### **Reviewer** 1

The manuscript by Yoon et al. describes novel measurements using an ECC sensor modified for sensing SO2. The measurement principle is similar to that of the measurements of ozone using potassium iodide solutions.

Figure S1: Schematic of the electronic concentration cell (ECC) for the SO<sub>2</sub> sonde. All italicized and underlined labels are items that were added to the traditional ECC for the SO<sub>2</sub> sonde.<sup>1</sup>"

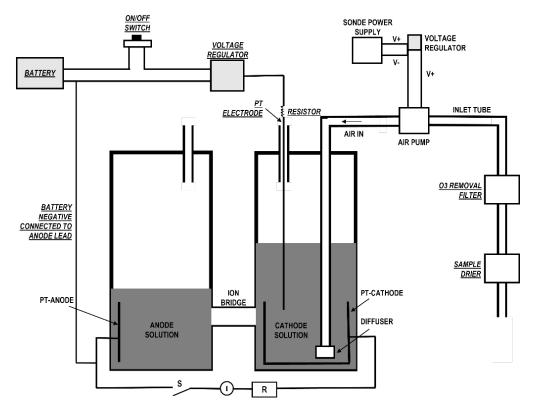
Comment 1: The paper refers to Flynn and Morris, which I assume is a reference to a patent. For clarity for readers not as familiar with ECC sondes, I would recommend including a schematic of the ECC and how the bias current is applied.

Comment 11: Section 3.2: It would be good to show a diagram of the sonde and of how the cathode cell is biased. It is not clear how the bias current is regulated. The text implies a fixed resistor between battery and electrode, which would make the current dependent on the battery voltage. The text also mentions a voltage regulator. Where is it used? Is the bias current through the cell regulated?

**Response**: The authors agree that providing a schematic of the ECC and more clarity in how the bias current is applied would be beneficial to the manuscript. A schematic of the ECC is included in the manuscript as Figure S1 in the supplemental document (P1ln2) and provided below. The schematic helps to visualize the construction of the bias current. Updated text describing the bias current is part of the response to Comment 2.

P6ln136 "The bias current is supplied by inserting into the cathode cell an additional platinum electrode powered by a 9V battery (Fig. S1) (Flynn and Morris, 2021). To maintain consistent power, the circuit

uses a 5V regulator. Varying the resistance allows for a range of bias currents to be introduced. The current version of the SO<sub>2</sub> sonde uses a fixed resistor which requires *a priori* knowledge of the desired SO<sub>2</sub> concentration range. The desired resistor is installed in series with the battery and the electrode."

Response: The authors agree that including a schematic of the  $SO_2$  sonde would be helpful in providing a better understanding of how the bias current is applied. The manuscript has also been updated to include clarity in how the bias is applied.

P6ln136 "The bias current is supplied by inserting into the cathode cell an additional platinum electrode powered by a 9V battery (Fig. S1) (Flynn and Morris, 2021). To maintain consistent power, the circuit uses a 5V regulator. Varying the resistance allows for a range of bias currents to be introduced. The current version of the SO<sub>2</sub> sonde uses a fixed resistor which requires *a priori* knowledge of the desired SO<sub>2</sub> concentration range. The desired resistor is installed in series with the battery and the electrode."
